ABP— 314485-22

Planning Appeal Online Observation

F20A/0668

Dublin Airport, Co Dublin

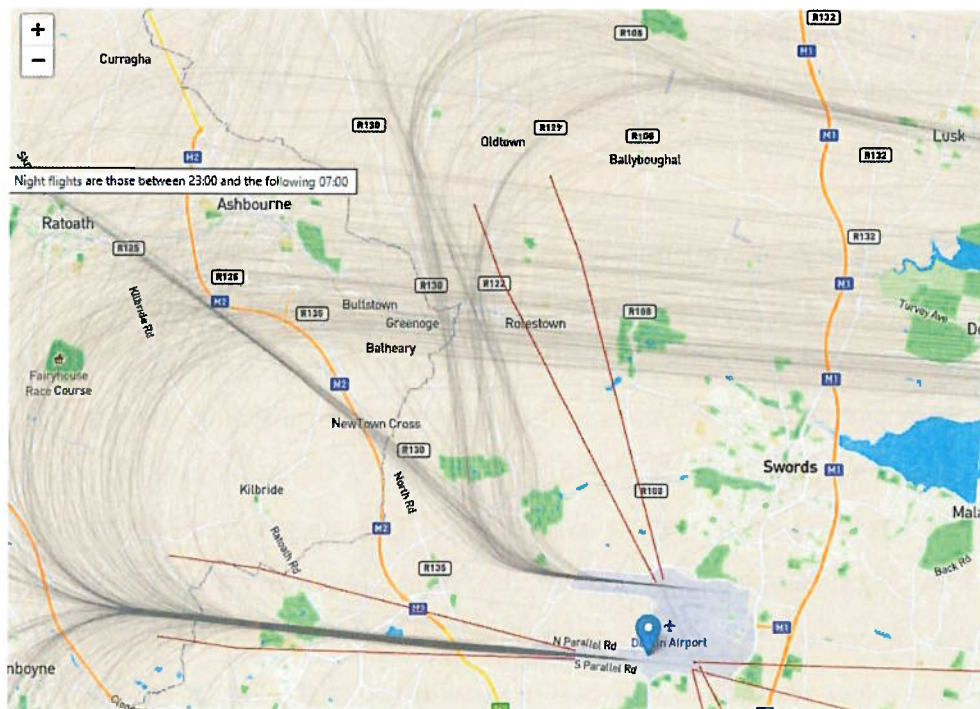
- Flying divergent flight paths on the North Runway for Westerly operations contravening the EIS of 2007
- Divergent flight paths currently in operation do not align with EIAR for this current planning application that is under appeal

- 30-degree divergence was not proposed in the 2016 consultation
- Condition 3 of planning does not allow for dual runway departures under Option 7b
- Flight paths used in Insulation Scheme approved by Fingal County Council in 2016, based on 2007 planning permission, show straight out operations

- Departures on North Runway on August 25-27th and all dates of westerly departures since opening are showing divergent routes contravening the planning permission from 2007
